ELECTRICAL POWER - CONTACTOR REPLACEMENT

MEL-24-02  
Page 1 of 2

28-VOLT STARTER CONTACTOR REPLACEMENT

**SK337-74**

Figure 1. 28-Volt Starter Contactor Replacement (Sheet 1)

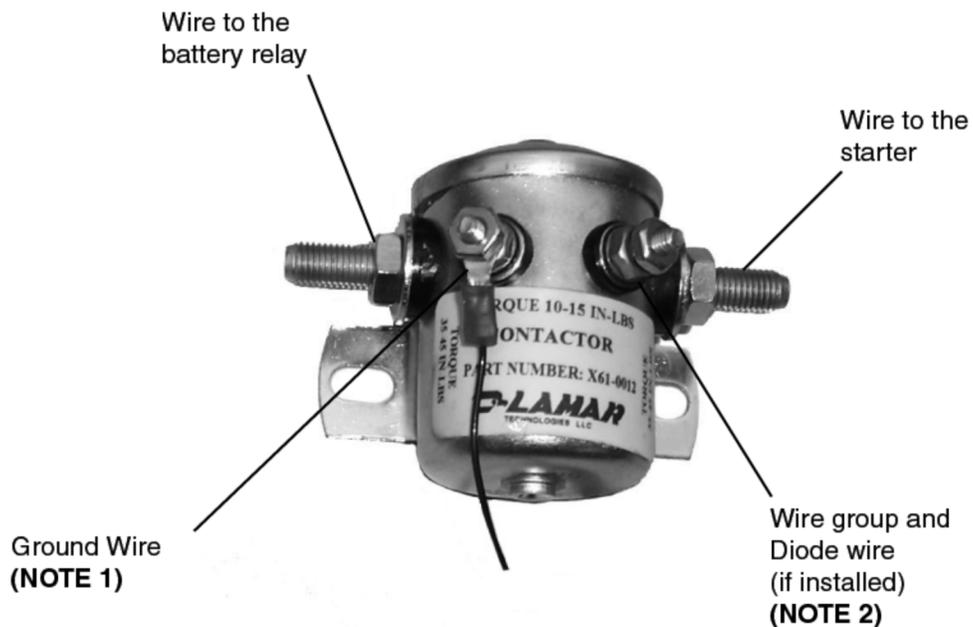
3. (Refer to Figure 1.) Remove and discard the 28-volt starter contactors. Keep the attaching hardware. (Refer to the applicable sections of the Service Manual.)
4. With the kept attaching hardware, install the two new P52-0016 28-Volt Starter Contactors. (Refer to the applicable sections of the Service Manual.)

**CAUTION:** Make sure that you install the wires to the same contactor mount bolts as shown in Figure 1. If you install the wires in a different configuration than the one shown in Figure 1, damage to the contactor and the equipment will occur.

**NOTE 1:** Install the ground wire to this stud.

**NOTE 2:** Do not install the ground wire to this stud, or damage to the starter contactor will occur.

**FIGURE:**

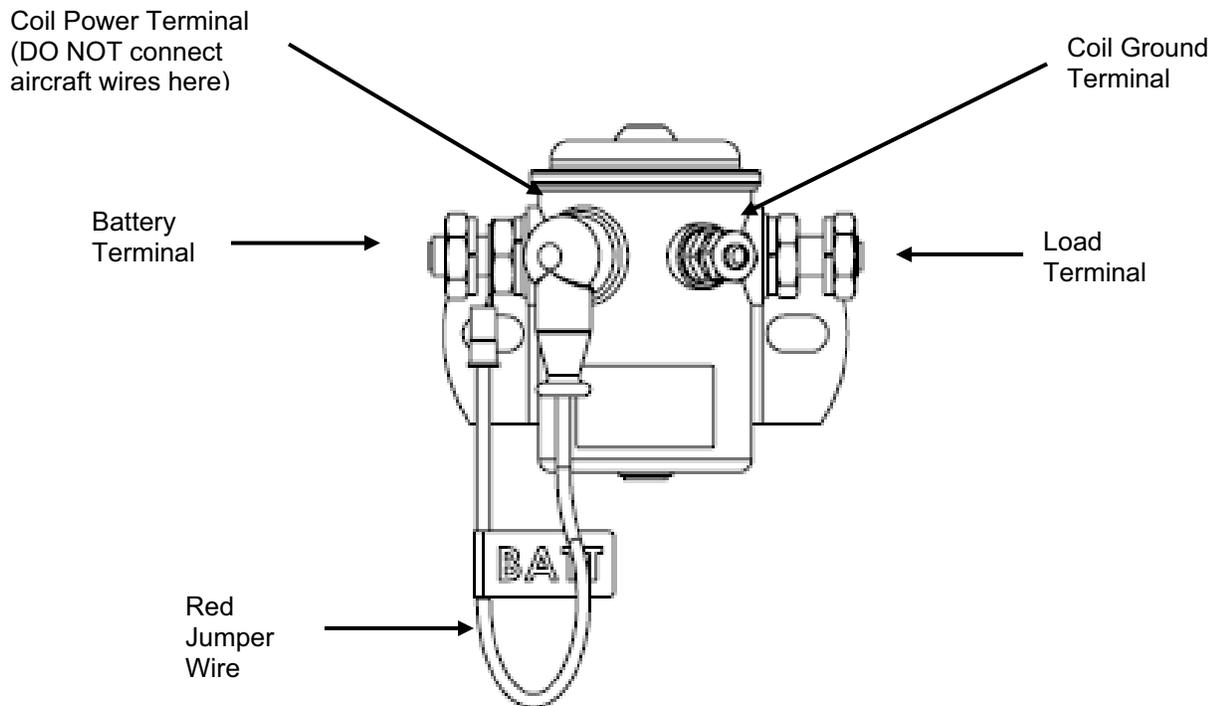
**SUBJECT:** This letter is to provide wiring installation instructions for Lamar P/N P52-0034-1 (12V Contactor kit) and Lamar P/N P52-0035-1 (24V Contactor kit) as a replacement for the Cessna P/N S1579 (12V) and S1580 (24V) contactors. These instructions shall be printed and distributed in the packaging with each contactor kit.

**INFORMATION:** Reference Figure shown below. The Lamar contactor kit will come with a red jumper wire installed from the Battery Terminal to the Coil Power Terminal. This jumper shall convert a 4 terminal contactor for replacement of a 3 terminal contactor. 3 terminal contactors (S1579 and S1580) have this connection inside the contactor without a coil power terminal. Aircraft wiring must control (on or off) the contactor coil through the Coil Ground Terminal and not have any wires (except jumper) attached to the Coil Power Terminal.
